PRODUCT CHANGE NOTIFICATION

Model SRN4018 Series Semi-shielded Power Inductors

Package Cover Tape Change

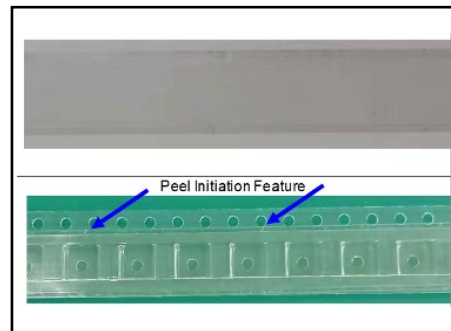
Riverside, California – August 3, 2021 – In the spirit of continuous improvement, effective February 5, 2022, Bourns will change the package cover tape from Pressure Sensitive Adhesive (PSA) to Universal Cover Tape (UCT) for [Model SRN4018 Series Semi-shielded Power Inductors](#). The Universal Cover Tape allows the removal of the middle section of cover tape while the adhesive edges remain attached to the carrier. This new cover tape may reduce an end user's assembly downtime associated with poor cover tape sealing and adhesive contamination that may occur with PSA cover tape. A list of affected part numbers is included below.

Current Package Cover Tape

Revised Package Cover Tape

Dimensions:

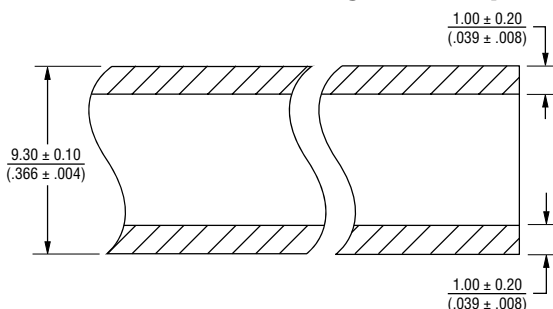
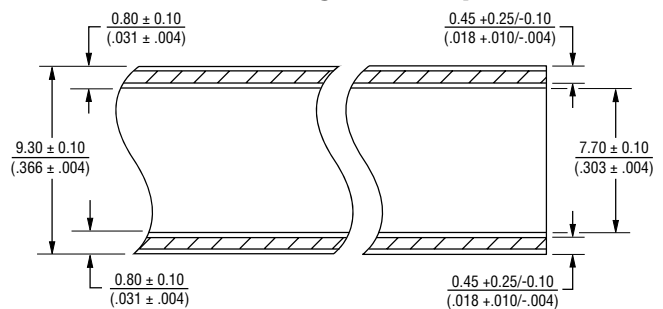
Current Package Cover Tape

Revised Package Cover Tape

Features	Current Package Cover Tape	Revised Package Cover Tape
Material	PET	Polystyrene
Color	Grey	Transparent
Thickness (mm)	0.062	0.060
Antistatic	$\leq 10^9$	$10^7 - 10^{12}$
Tensile strength	$\geq 29.4\text{N/mm}^2$	$\geq 6\text{N/mm}^2$
Peeling strength	20 – 80g	15 – 60g
